Mallinckrodt Inc.

RE: License Number 24-04206-01; Docket Number 030-00001

Mallinckrodt Inc.
List of Changes in the Current
Application for Amendment to License No. 24-04206-01

APPLICATION FOR MATERIALS LICENSE

Figure 7.1

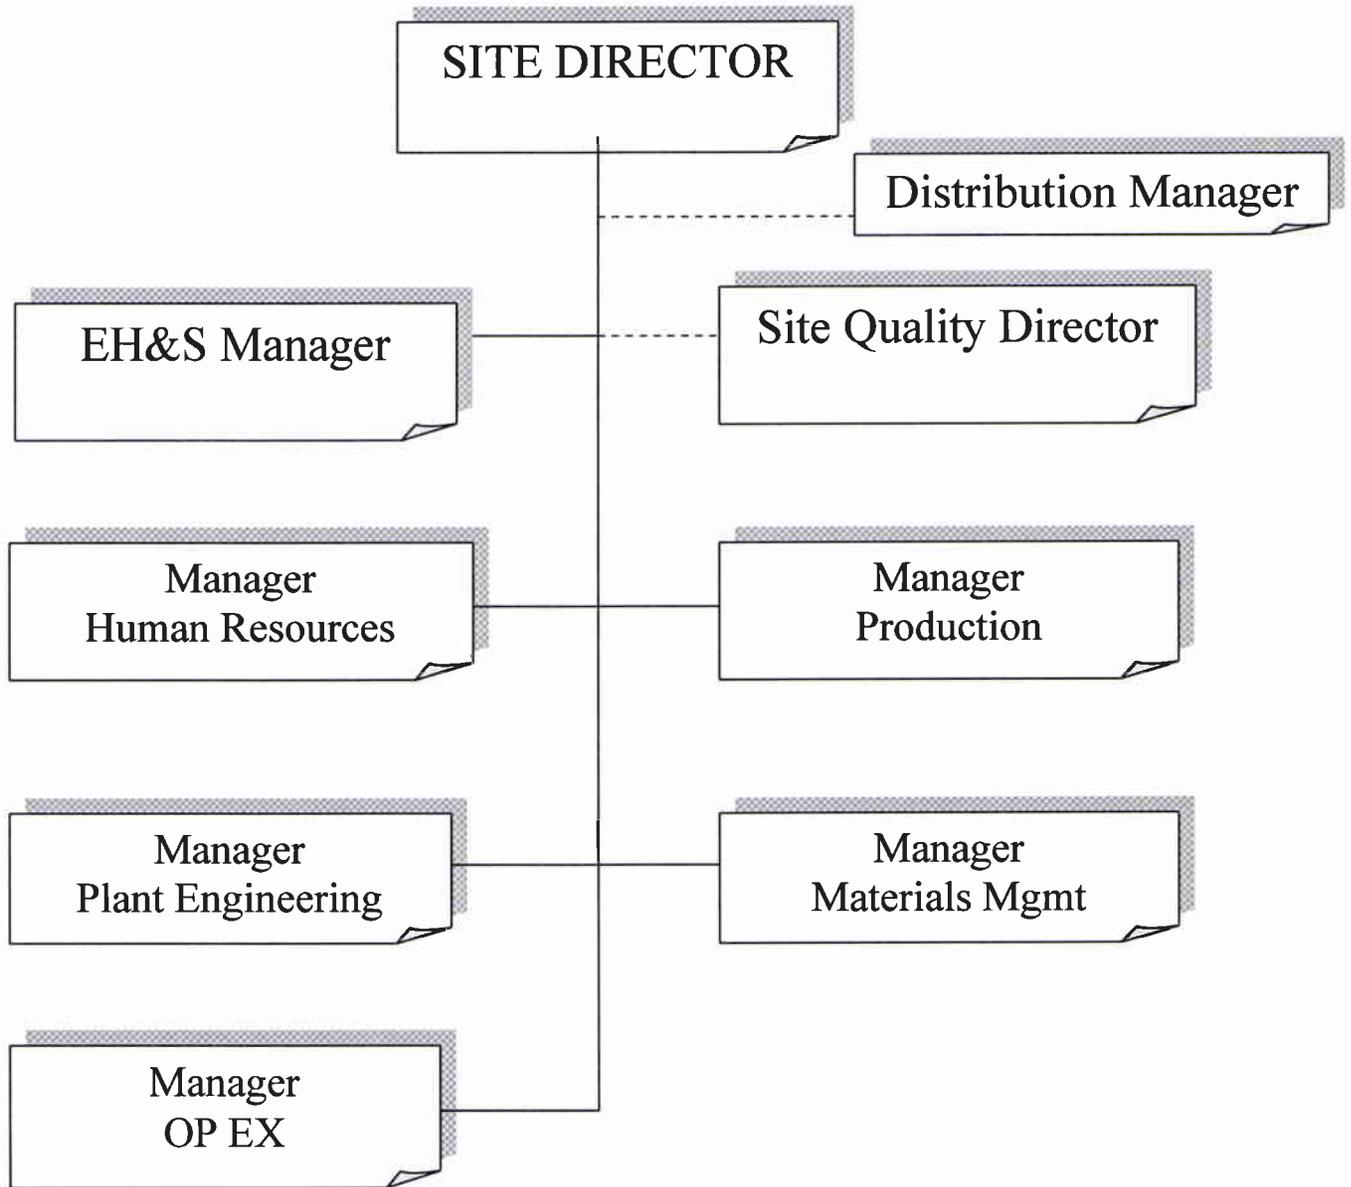
1. Page 7: Under the “Radiation Safety Committee” section, the list of positions represented on the committee were updated.
2. Pages 8 and 9: Figures 7.1 and 7.2 were updated to reflect the current organizational and reporting structure.
3. Page 11: In the sentence beginning with “Prior to implementation”, the term “license renewal application” was changed to “application for license amendment”.
4. Page 14: The last two paragraphs on the page regarding delegation of RSO authority were reworked and combined into a single paragraph.

Figure 9-4 Lab 1B Generator Lab Plan View

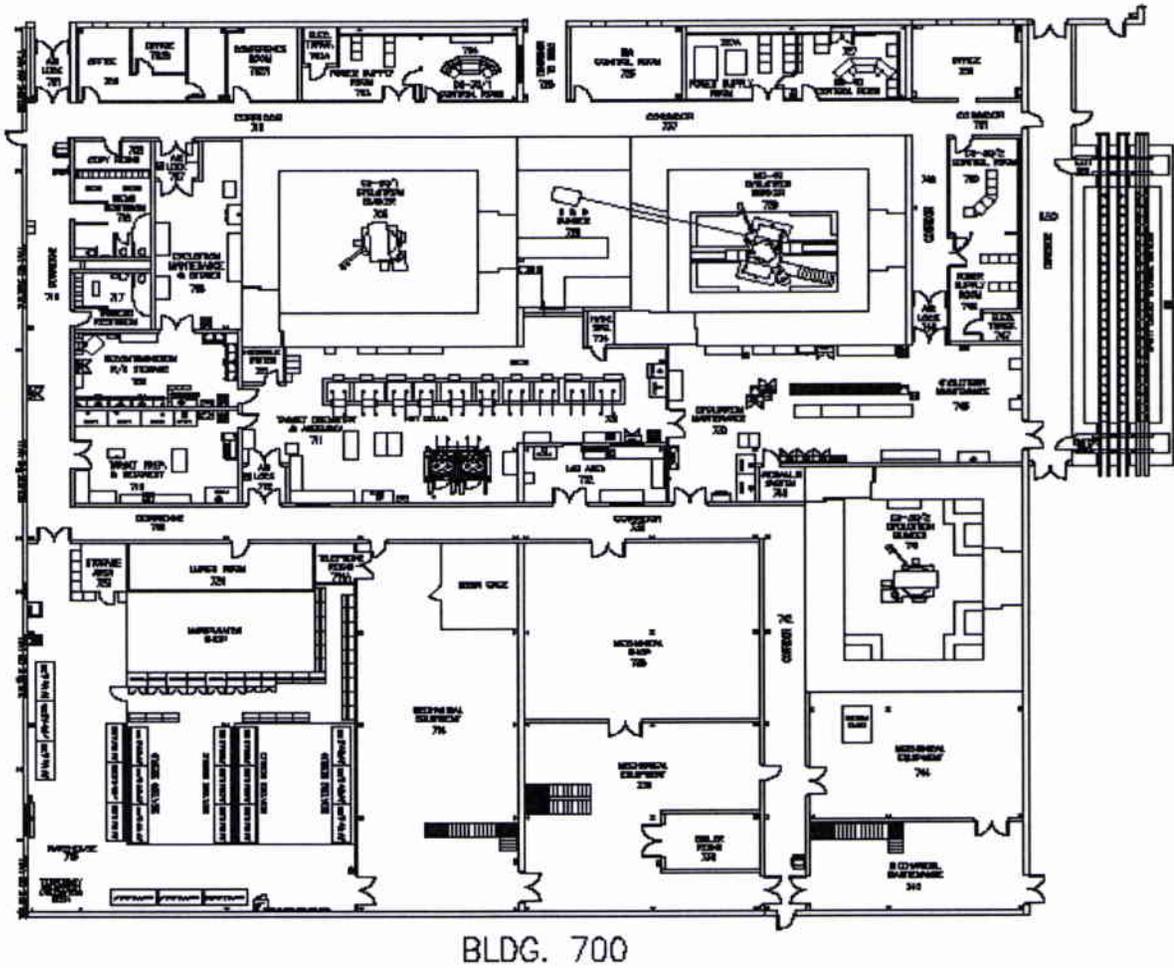
5. Page 27: The section titled "Building 600" was revised to incorporate activities and facilities where cyclotron produced radionuclides are received and processed. Also makes reference to a new Figure 9.5 that shows the layout of the R/A Processing, R/A Dispensing and R/A Packaging Labs.

Figure 9-6, Building 700 Plan View

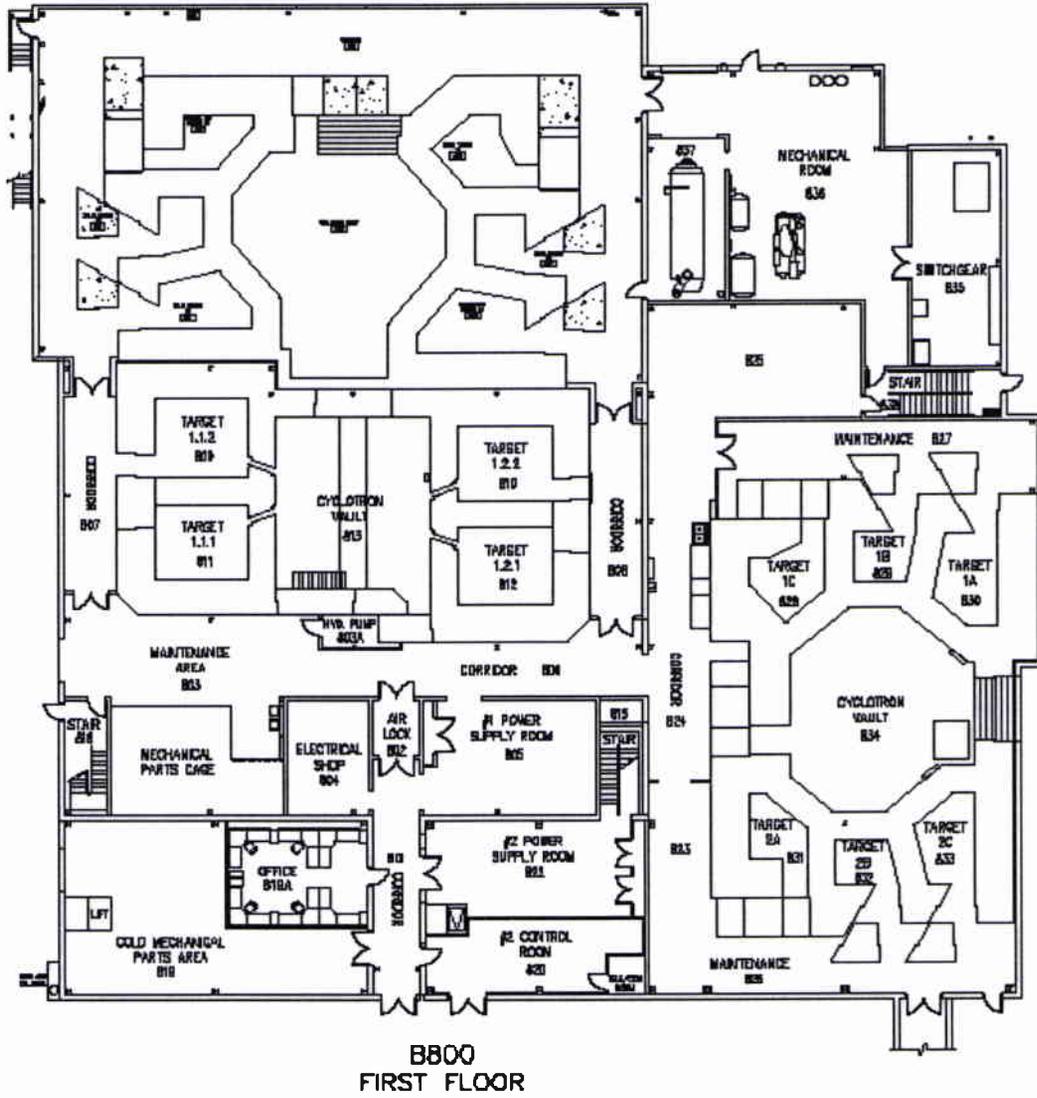
9. Page 28: Added a paragraph to reference Table 9-3, General Information on Maryland Heights Cyclotrons. Created a new Table 9-3 that provides information regarding the six cyclotron units at the Maryland Heights plant. Added a paragraph after Table 9-3 that references the floor plans for Buildings 700 and 800. Also includes reference to the location of the two primary labs where processing of cyclotron targets occurs.

10. Pages 29-34: Added updated drawings of the site and added new drawings for the buildings that house the cyclotrons.
11. Page 36: The last sentence in the third paragraph was revised to read as follows:
